MEMORANDUM FOR: Docket File No. 40-1341
FROM: T. L. Johnson
Licensing Branch I
Uranium Recovery Field Office
Region IV
SUBJECT: REVIEW OF NEED FOR ADDITIONAL MONITOR WELLS -
EDGEMONT MILL

SUBJECT: ORNL Review of Draft License Condition No. 27 Related to the Decommissioning of the Edgemont Uranium Mill

FIGURE 2-11. SURFACE DRAINAGE AND MONITOR STATIONS

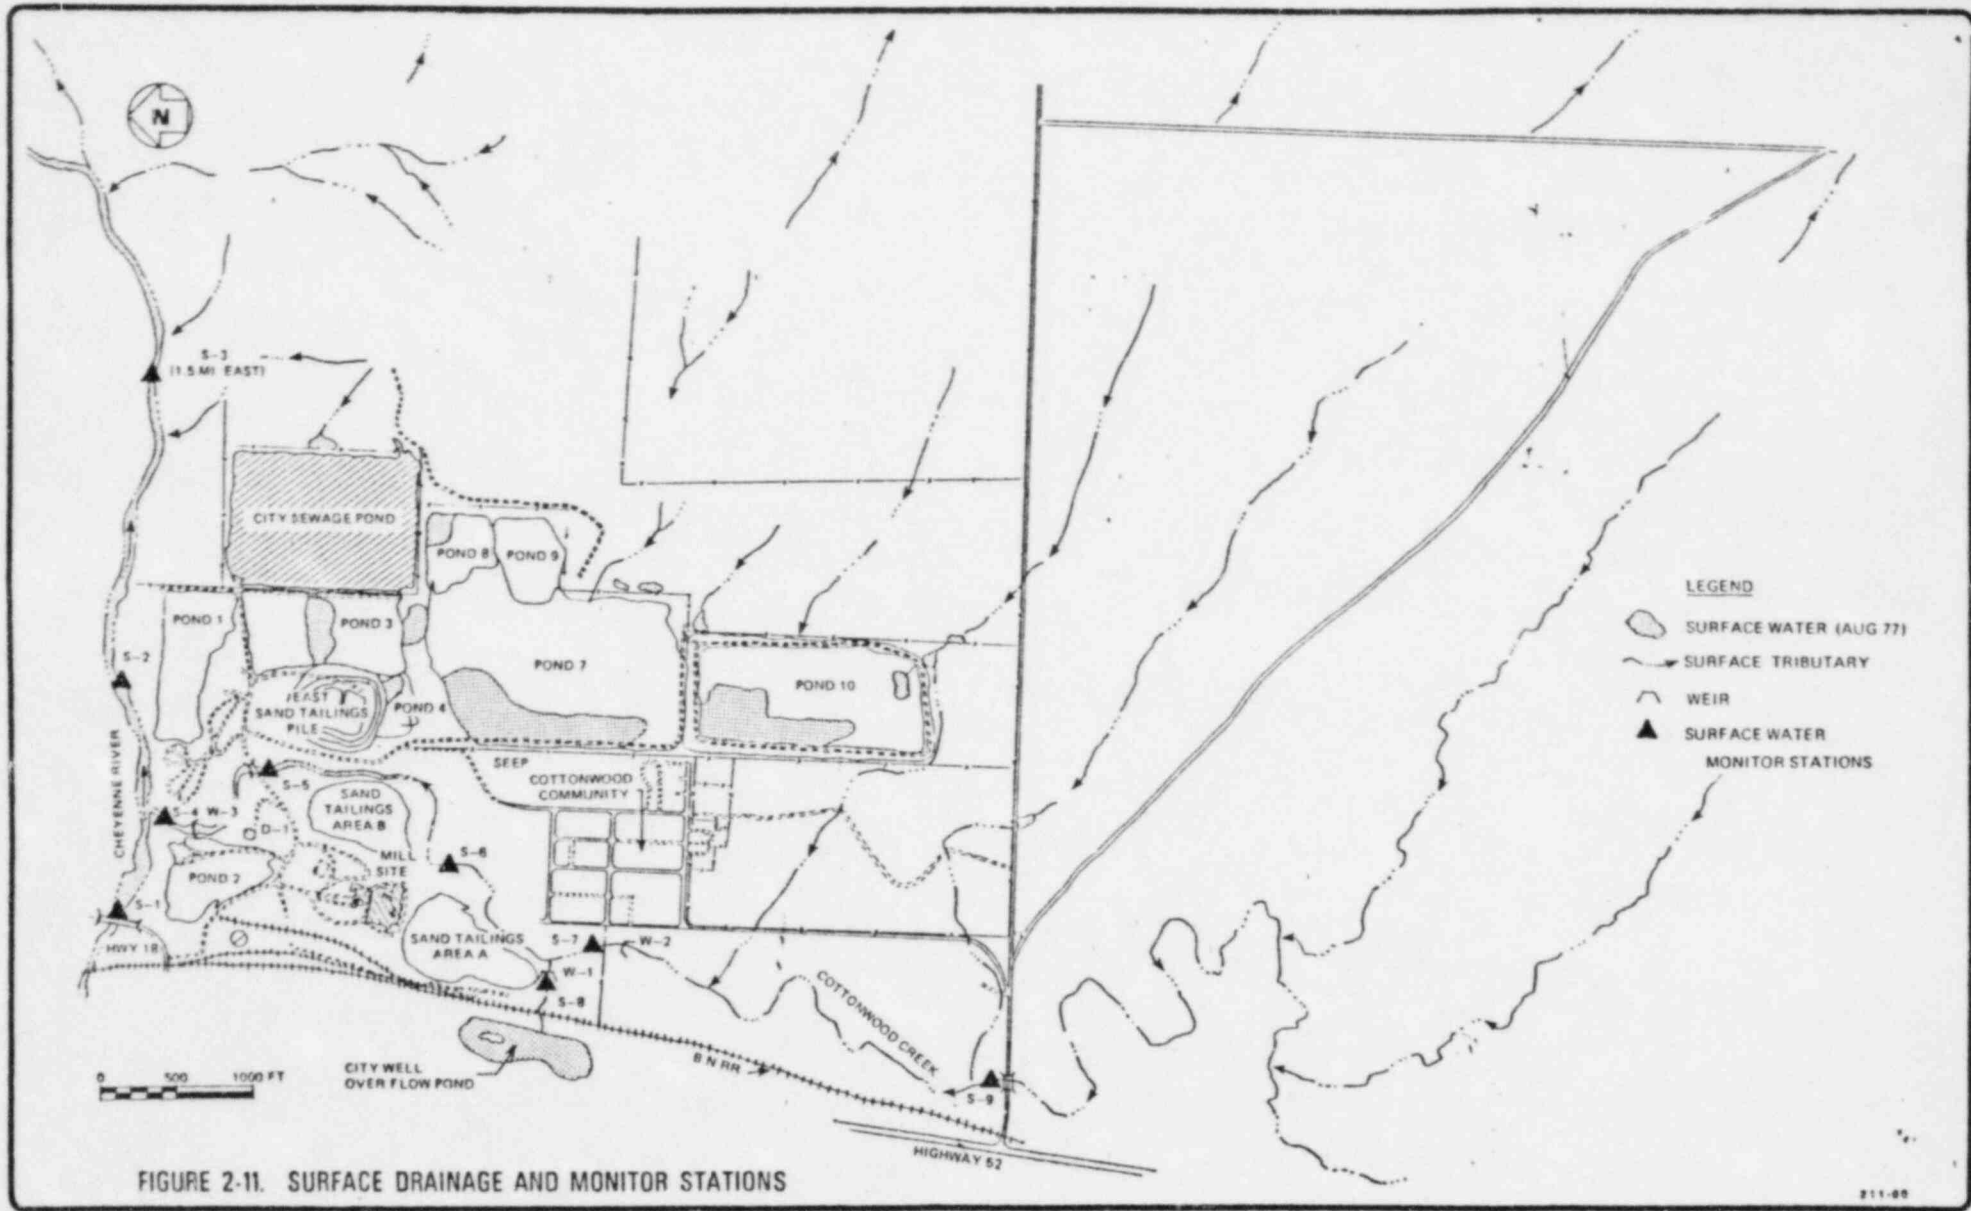
Examination of Fig. 2.11 indicates that there may exist one and portions of two other buried stream channels beneath Pond 10. These buried stream channels or portions of their remnants could act as high permeability conduits for the migration of contaminants resulting from any seepage that might occur from Pond 10. If these high permeability conduits exist, seepage could be directed towards the Cottonwood community. Additionally, the Ford, Bacon, & Davis report indicates that seepage may be occurring through the beams of Pond 10. If these observations prove to be correct then our staff recommends that both the bottom and the sides of the beams of Pond 10 be lined.

FIGURE 2-12. GROUND WATER LEVEL CONTOUR AND FLOW DIRECTION MAP

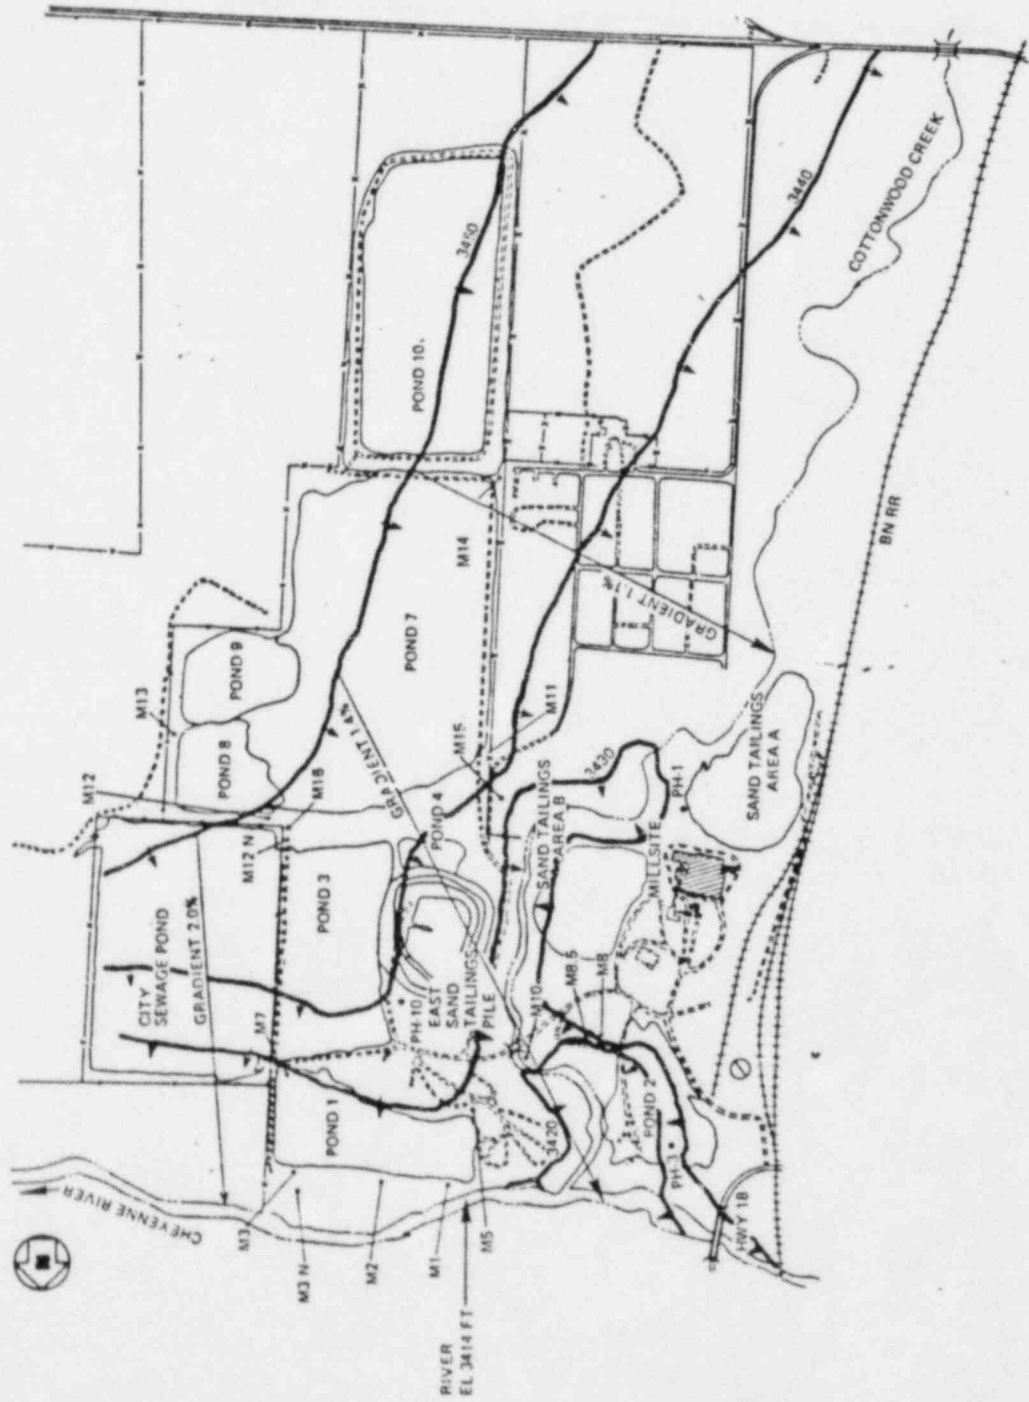
Pond 10 is located hydraulically up gradient from the Cottonwood community (see Fig. 2.12) and will be used as a holding and solar evaporation pond for approximately five years or until the final stages of decommissioning. Pond 10 will receive water from the diversion channel, excess surface water from dewatering sumps located in various parts of the site, the median drain from between the haul roads, and water that is decanted from the proposed tailings disposal site. This implies that the head in Pond 10 may increase substantially over short or possibly extended intervals of time. An increase in head could induce seepage in either the vertical or horizontal directions.
